LOCAL HISTORIC DISTRICT:	Wilmore
PROPERTY ADDRESS:	1826 Wickford Place, Lot 3
SUMMARY OF REQUEST:	New Construction
APPLICANT:	Craig Calcasola

HDC-2019-00365 PID: 11907747 LOCAL HISTORIC DISTRICT: WILMORE PROPOSED PROJECT: CONSENT AGENDA

July Meeting 2019

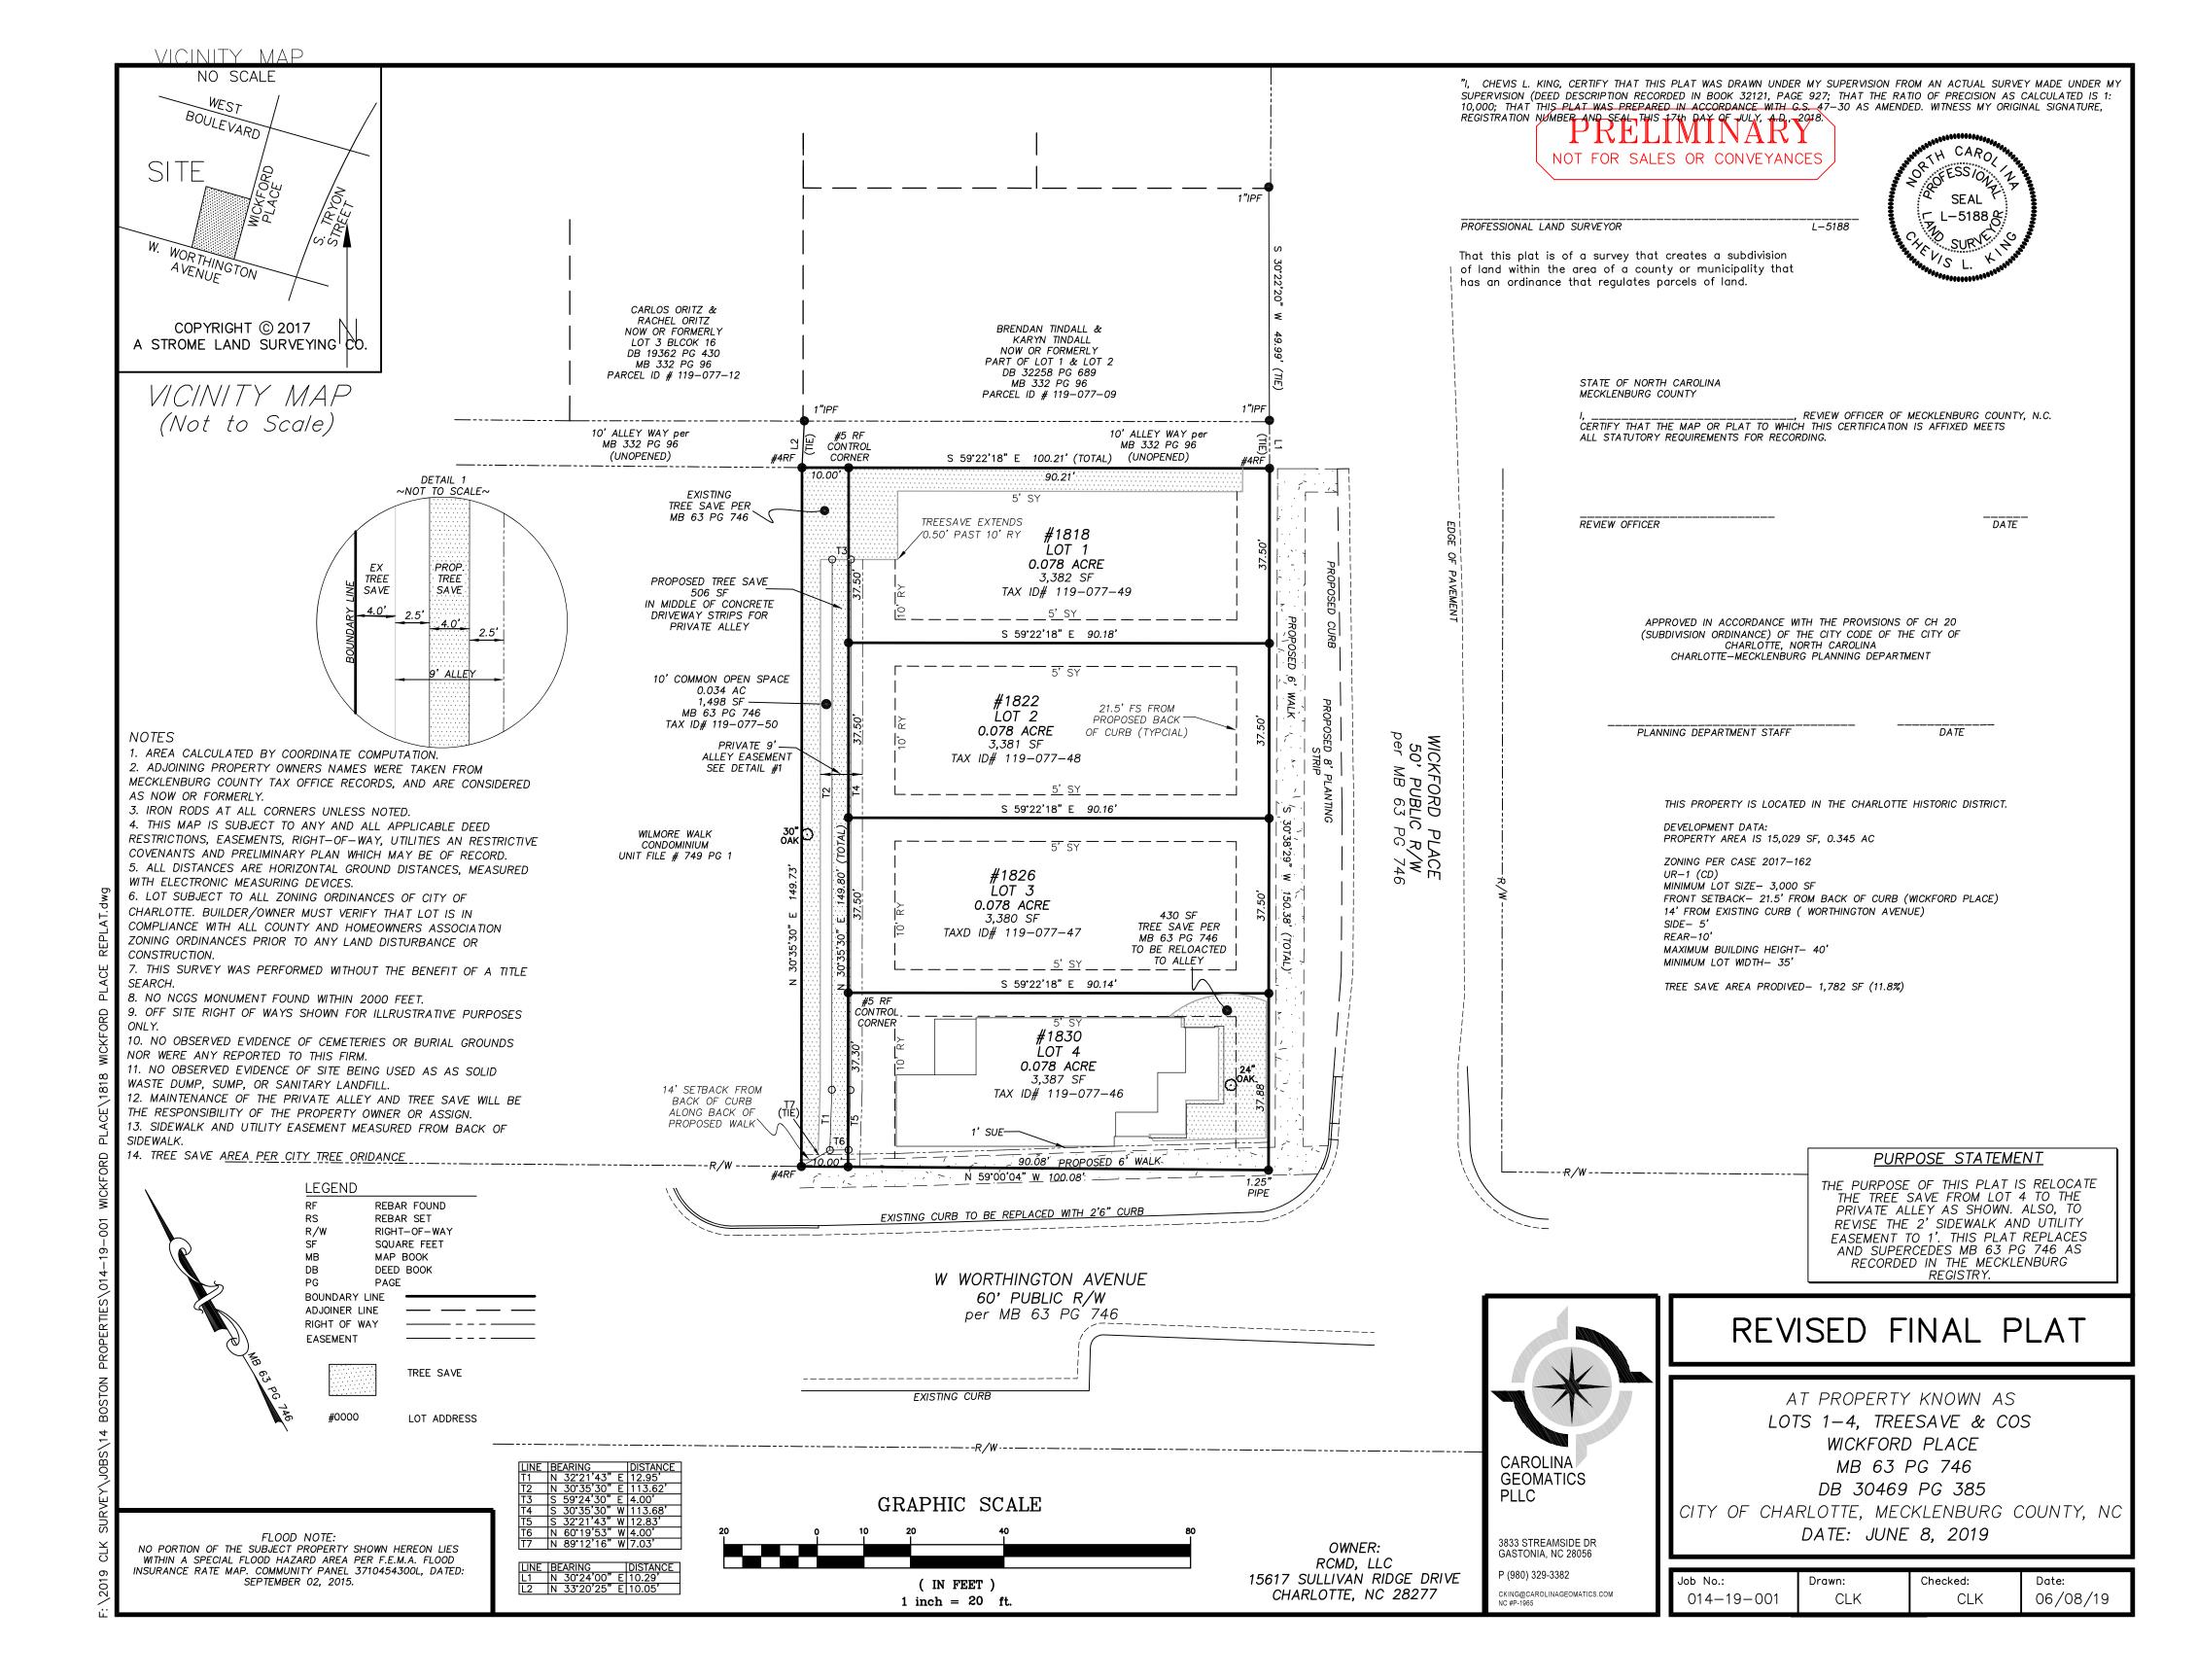
- 3. Roof overhang not changed per condition.
- 4. V-groove bead board soffit not noted on plans.
- 5. Staff concern over Elevation Notes on A3.1 that German-style siding, door, and window styles to be selected by owner.
- 6. The project is not incongruous with the district and meets guidelines for New Construction.
- 7. Staff Recommends reinstating the **Approval with Conditions with Staff to work with applicant**, per 10.4.1 of the Rules for Procedure.
- 8. If requested by a Commission member, or if an interested party has signed up to speak in opposition, then the HDC shall open the application for a full hearing.

STREETSCAPE

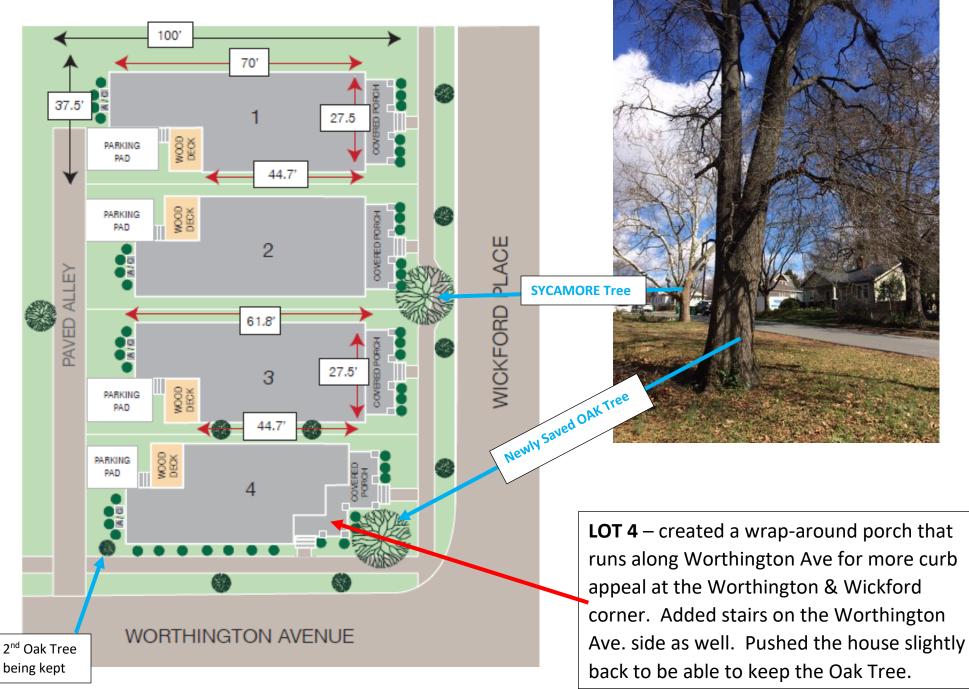
UPDATED – LOT 2 added columns from ceiling to floor on the front porch

HOUSE VARIATION STREETSCAPE

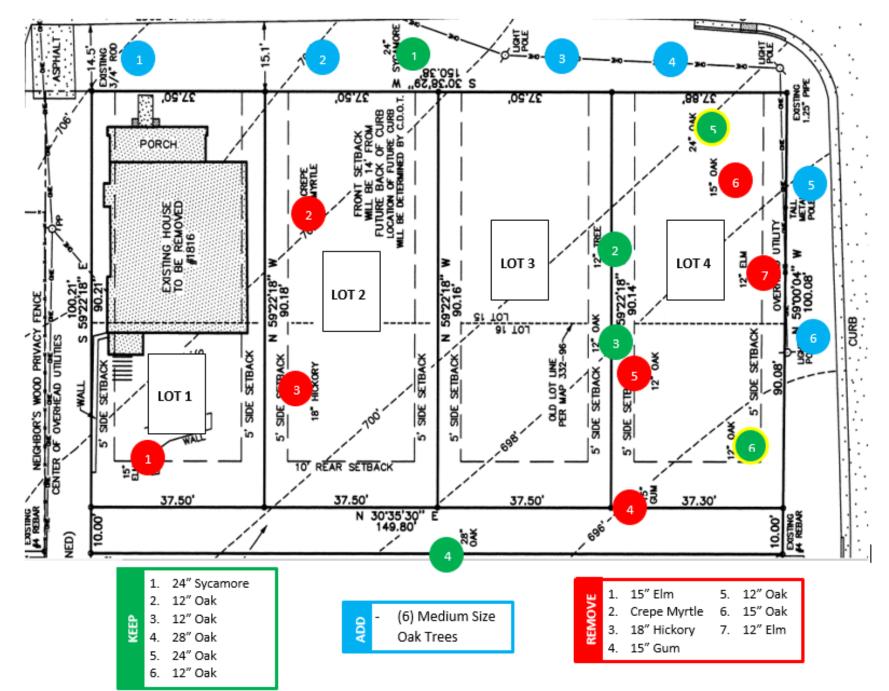
- LOT 1 stays the same but we have taken the roofline down 1 ft.
- LOT 2 stays the same but we have taken the roofline down 1 ft.
- LOT 3 the **front dormer has a gable above it**, and the roofline came down 1 ft.
- LOT 4 the front porch wraps-around along Worthington and is positioned for us to save the Oak Tree

LOT 3 - HEIGHT / MASSING

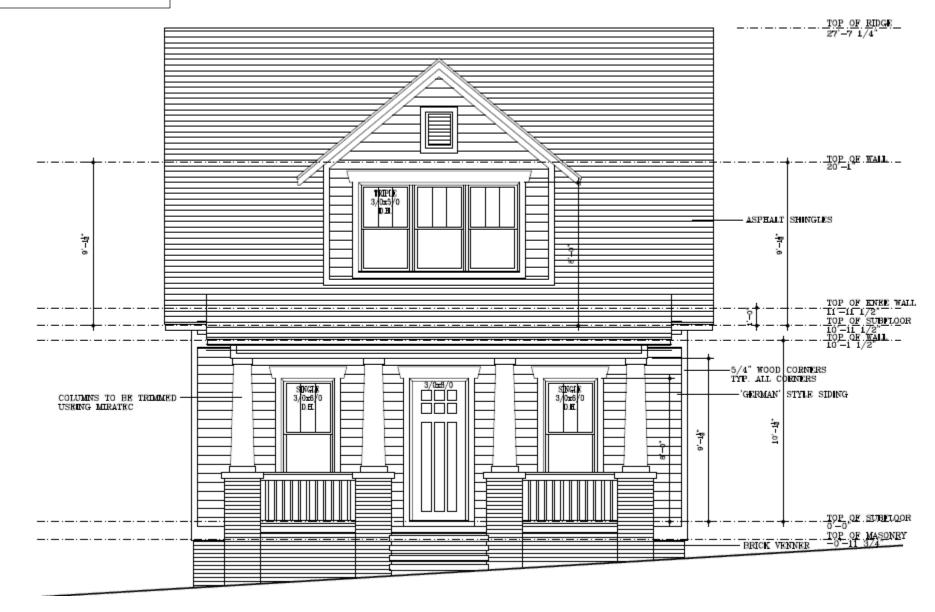
• We have reduced the roofline by 1 foot to 27' 7.25", by making the 2nd Floor 9' ceiling height.

Wickford Place (our side including the neighbor's house to the right of our property)

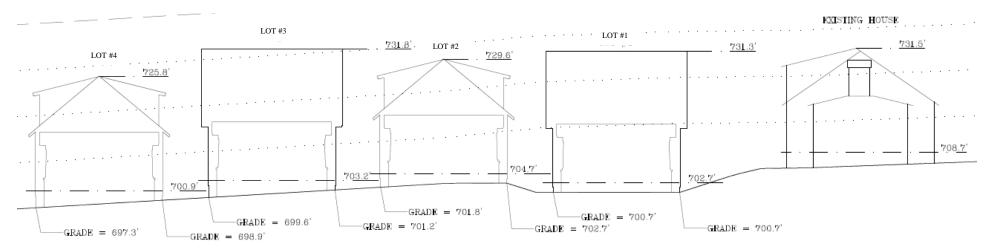
- Our <u>Hip Roof Houses</u> are within 3 inches of our neighbor's roofline and within 4 feet of the roofline across the street.
- Our Gable Style Houses are 2 feet lower than our neighbor's roofline and between 2-3 feet of across the street.

WINDOW DETAIL – UPDATED

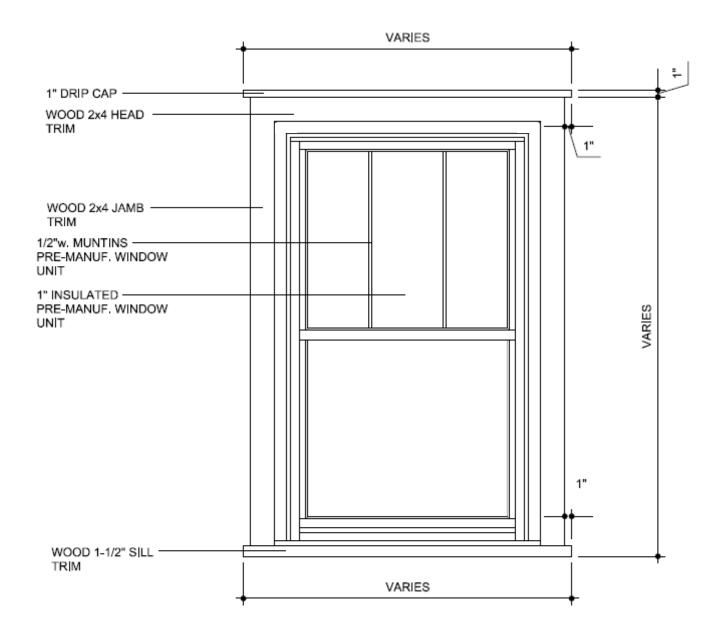
The underlying zoning will require an 8' planting strip and 6' sidewalk. New landscaping and tree save opportunities are shown on the site plan. Included in the plan is a new private alley at the rear for the four houses. The revised plans also include numeric evidence of comparable lot coverages in the neighborhood, pervious area more clearly shown on the site plan and updated window design and placement.
